Design Features and Technology Uncertainties for the Next Generation Nuclear Plant

Independent Technology Review Group

June 30, 2004

*Idaho National Engineering and Environmental Laboratory
Bechtel BWXT Idaho, LLC*

Figure 1. Schematic illustrating the level of risk as the degree of materials development complexity increases.

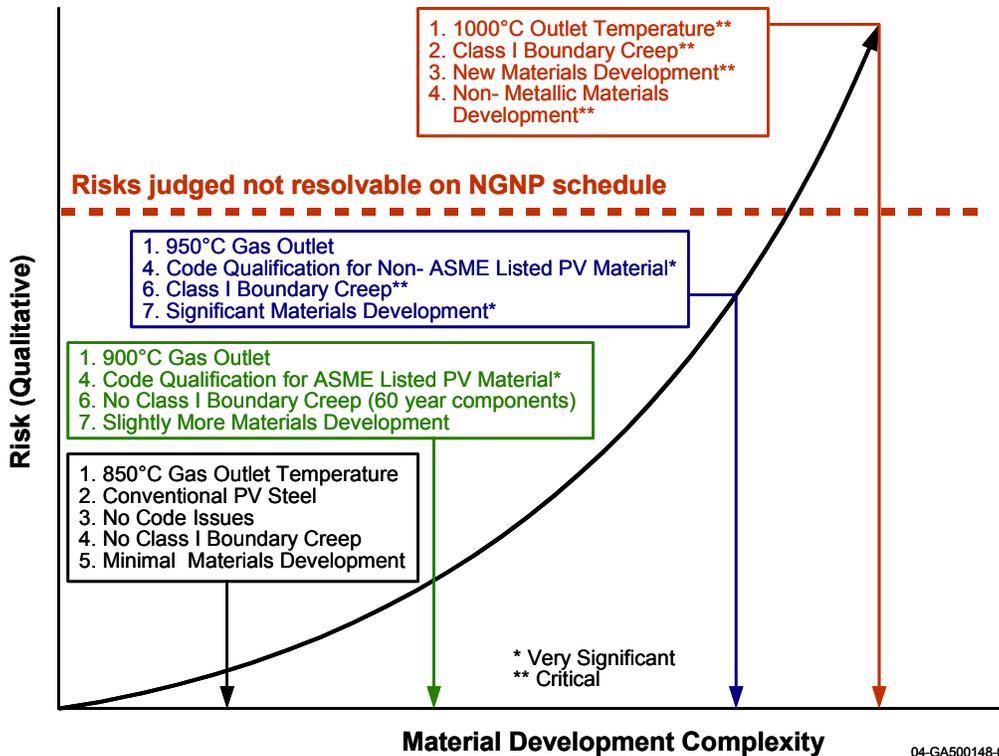
Figure 1 shows the degree of risk as a function of materials-development-related “complexity.” By increasing complexity we mean that the materials problem gradually becomes more significant with interdependent issues as the gas outlet temperature increases.

By far the most significant risk with respect to materials is associated with the requirement for a gas outlet temperature of 1000 °C or higher. Operation at 1000 °C may eliminate the indirect cycle and hydrogen generation at this temperature. This requirement essentially eliminates metallic materials for an NGNP on the construction schedule identified. The high temperature would also greatly aggravate the risks associated with ASME code qualification, welding, and processing, and essentially all of the other risk factors identified. As a result of this, it is our judgment that a gas outlet temperature of 1000 °C or higher represents a significant risk for successful completion of NGNP on the specified schedule. A more realistic, achievable, maximum temperature of 900 °C for metallic components was arrived at by general consensus.

The next most significant risk factor is that associated with the allowance of creep deformation in the Class I pressure boundary. The high gas outlet temperatures anticipated for the NGNP require use of materials for the pressure boundary that are at least capable of operating at temperatures above those of current pressurized water reactors, an attractive option from a plant efficiency point of view. However, while some (very few) of the current pressure vessel materials are capable of higher temperatures, operating at metal temperatures and stresses where creep or creep-fatigue mechanisms are significant represents a very substantial departure from current practice. The allowance in the design for creep during operations will also result in a very significant increase in the R&D costs, as well as the required component inspection and monitoring. The judgment of the ITRG is that, while operating in the creep regime is possible, the achievement of this goal on the time frame of the NGNP will not be practical. The ITRG therefore recommends that creep deformation not be allowed to be significant for irreplaceable (60-year life) components that are a part of the Class I boundary, such as the pressure vessel and primary system piping. For Class I components that could be replaced on a more frequent interval, such as the IHX, creep deformation may be allowed but at the expense of significant real-time monitoring and inspection.

Figure 3. Direct cycle power conversion unit with helium main heat transfer loop.

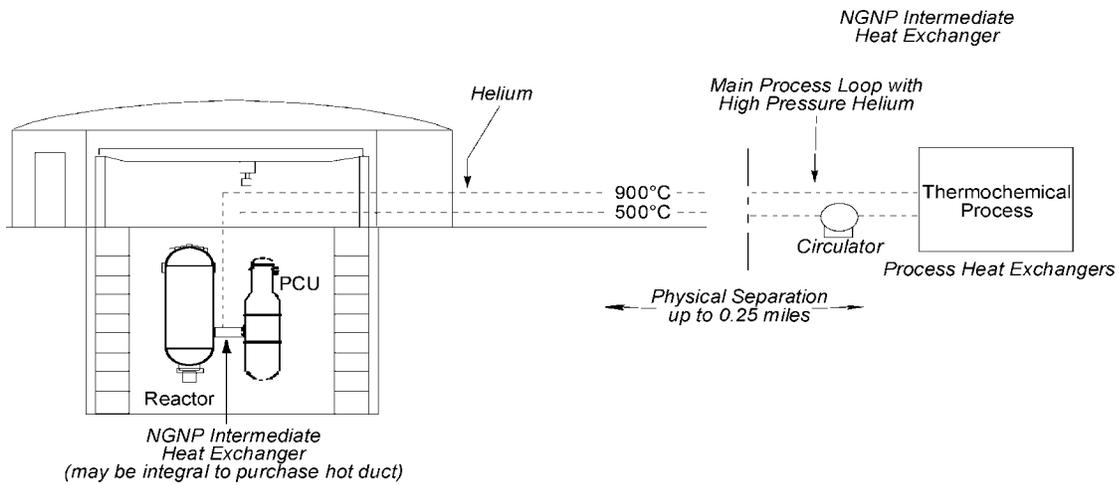
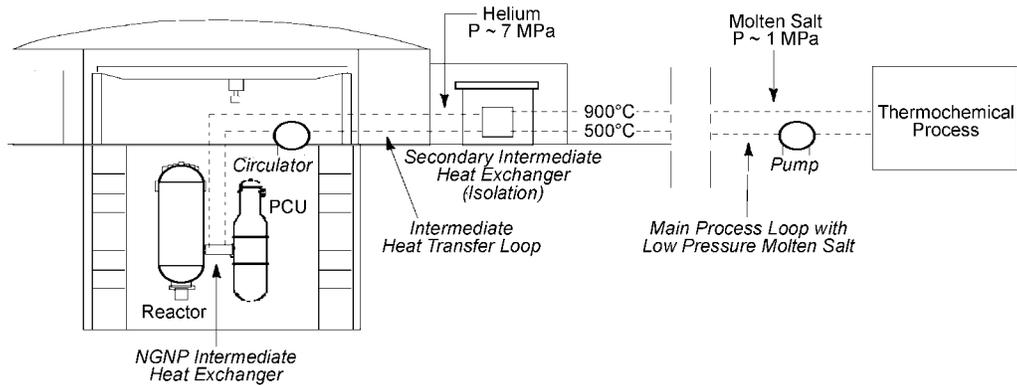
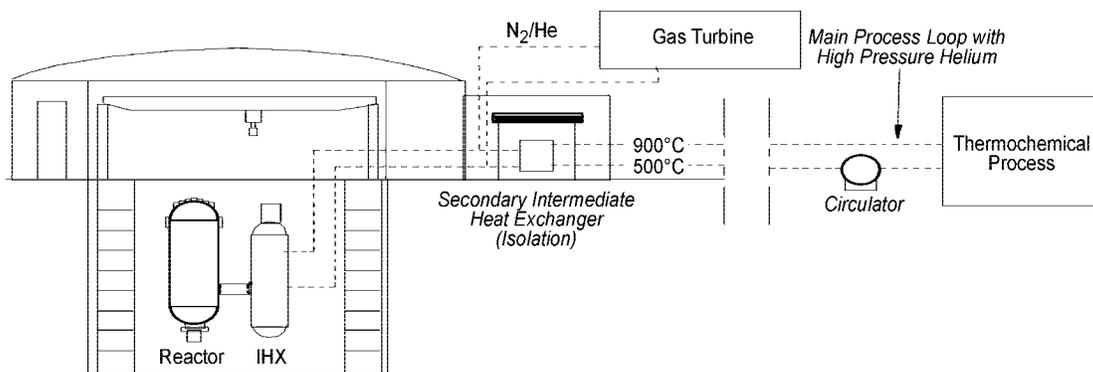
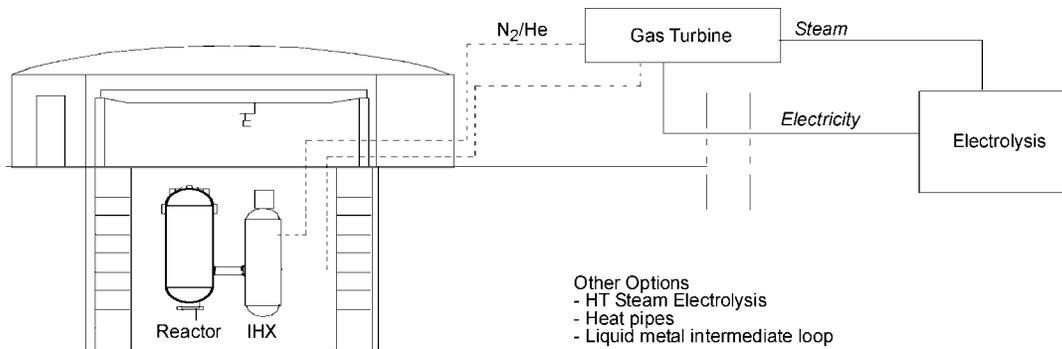
Technical Justification. The designs and materials of construction of the NGNP IHX, any secondary IHXs used in the system, hot gas ducts, molten salt loops (if used), and the process plant heat exchangers (see Figures 3 through 6), have yet to be determined. All of the heat exchangers must exhibit high specific heat transfer area (up to 1000 m²/m³) and be able to operate at temperatures as high as 1000 °C. Candidate designs include the Heatric Printed Circuit Heat Exchangers (PCHEs), plate-fin devices, prime surface recuperator-type designs, and possibly C-C composite strip fin designs. Testing of PCHEs is being pursued by at least one vendor for helium-helium service. Use of helical shell and tube designs for helium-helium service applications may be possible, but the surface-area-per-unit-volume goals are unlikely to be met (HTTR uses such a design fabricated from Hastelloy XR). Other open issues include whether heat exchangers of the size required can be manufactured and how they would be inspected, serviced, and cleaned/decontaminated over the life of the plant. The specific Code requirements and Class 1 to Class 2 boundaries for the IHX are also not clear. Some needs may also exist for establishing accurate heat transfer data such as heat transfer coefficients. The JAERI Helium Engineering Demonstration Loop (HENDEL) operated in the early to mid 1990s to evaluate He heat transfer performance at up to 1000 °C. Data from this loop may contribute to the design of the IHX by providing experimentally determined heat transfer coefficients. Experience from HTTR is also likely to be valuable. Other valuable experience that should be factored into the NGNP development effort was obtained in Germany in the 1980s through the early 1990s. Research expenditures associated with the design of a process heat plant were reported to have been about \$2 billion. These efforts included testing of hot gas ducts and various heat exchanger designs.

- Consider use of an intermediate heat transfer loop between the NNGP and the hydrogen production plant that will provide for additional isolation of the two plants.

- Consider use of two boundaries between the nuclear plant and the hydrogen production facility. In this arrangement, an intermediate helium heat transfer loop at high pressure (greater than reactor system pressure) would be coupled to a second IHX that transfers heat to either a gas or molten salt loop. The gas or molten salt loop would be the primary method of energy transfer to the hydrogen production plant over long distances.

Figure 7. Key issues related to licensing NGNP with thermochemical hydrogen production.

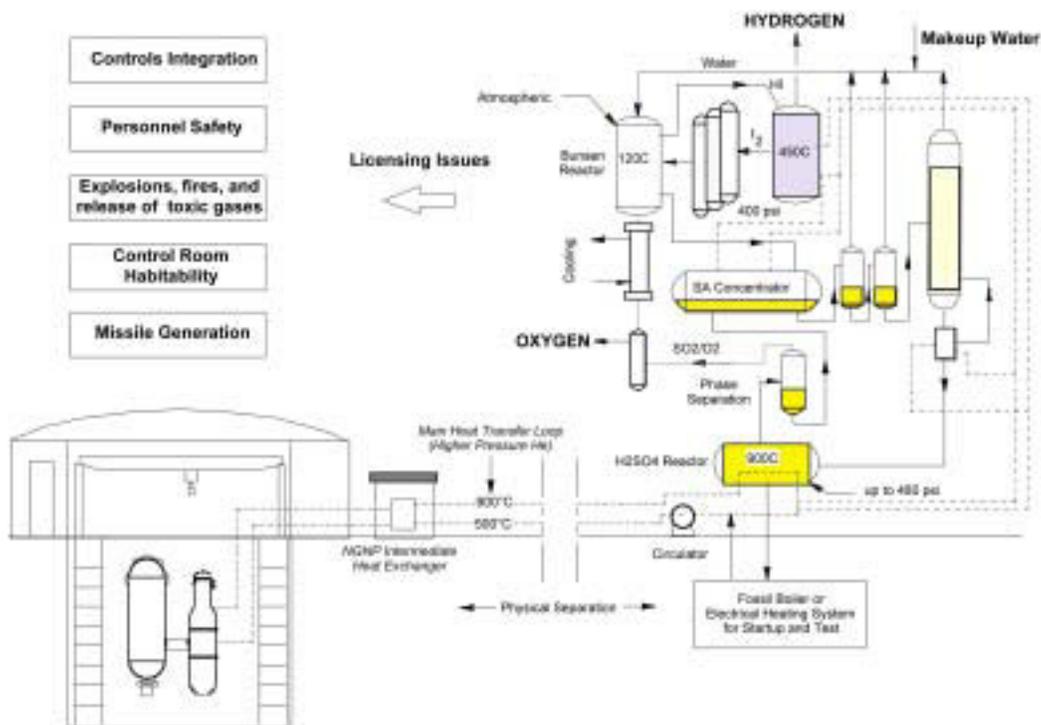
Technical Observation. Licensing of the NGNP will require evaluation of the potential for external events associated with the hydrogen plant, including (1) explosions, fires, and release of toxic gases, (2) control room habitability, and (3) missile generation. It is unclear that these issues have been addressed sufficiently to date, and therefore, they contribute to technical risk. Figure 7 illustrates the key issues related to licensing the NGNP with thermochemical hydrogen production.

Associated Risk. The primary risk is associated with an inability to license the NGNP because of unacceptable hazards posed by the hydrogen production facility. A secondary risk is that events at the hydrogen production facility could damage NGNP structures, systems, or components, corresponding to an investment risk.
